AMENDMENT A00003 TO
SOLICITATION VA262-15-B-0027
ATTACHMENT 2

RFI (REQUEST FOR INFORMATION)			
PROJECT NO.:	664-11-165	RFI NO.:	2
PROJECT NAME:	Building 1 Remodel – Hot & Cold Water Riser Modification	DATE REQUESTED:	5/22/15
SOLICITATION NO.:	VA262-15-B-0027	REFERENCE:

Figure 12 – Minimum Clearances for Unit-mounted Service Disconnect

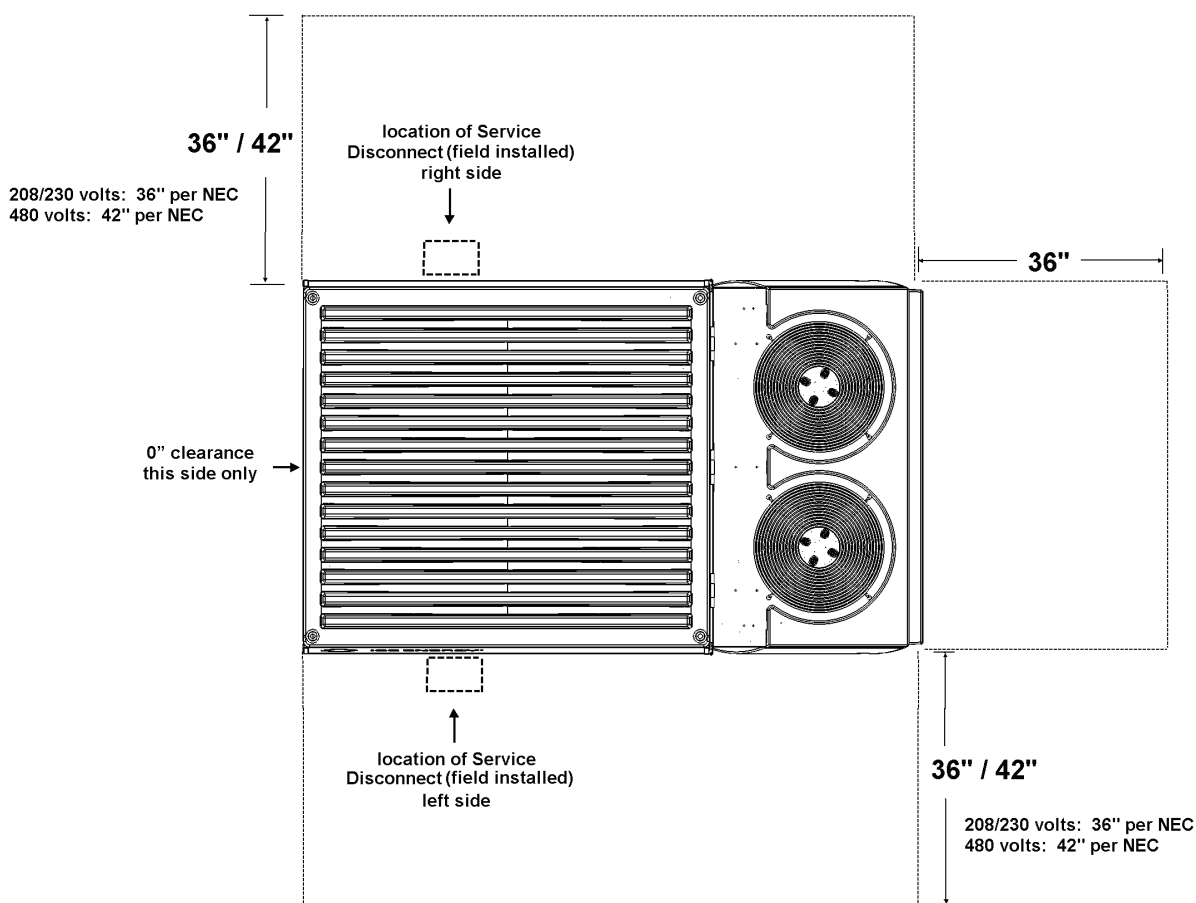
DRAWING:	H-112	SPECIFICATION SECTION:	
22DESCRIPTION OF PROBLEM OR INFORMATION BEING REQUESTED			
<p>Please be specific as possible:</p> <p>The MRI Building is showing four new AC units to be on grade. The sizes provided for the units, to include necessary clearances, total approx. 45ft in length, and 10ft from the building. The area currently designated to receive these units is not long enough or wide enough for these to all fit. Currently there is a large palm tree, a set of stairs, and the road curving towards the building in the area; as well as a new screen wall being shown. Please clarify the intent of the facility for the current location; is the palm tree to be removed? Are the stairs to remain? Will the road need to be narrowed away from the building?</p>			
PROJECT MANAGER'S RESPONSE			
TRACKING NO.:		AMENDMENT NO.:	
VA PROJECT ENGINEER/MANAGER:		DATE:

As noted on General Note # 1 on sheet H-112, TES scope is presented diagrammatically and shall be further developed by the contractor. Refer to attached TES clearance requirements and MSK-1 layout reflecting the outline of the driveway and indicating the screen wall boundary adjustment.

In addition to the minimum clearances depicted in the figures below, ensure that a 60" vertical clearance exists to provide for proper CONDENSER FAN operation. Note that Figure 12 covers clearances for ICE BEAR UNITS with a unit-mounted SERVICE DISCONNECT SWITCH. For ICE BEAR UNITS with an internal SERVICE DISCONNECT SWITCH (located in the ELECTRICAL CONTROL BOX), refer to Figure 13.
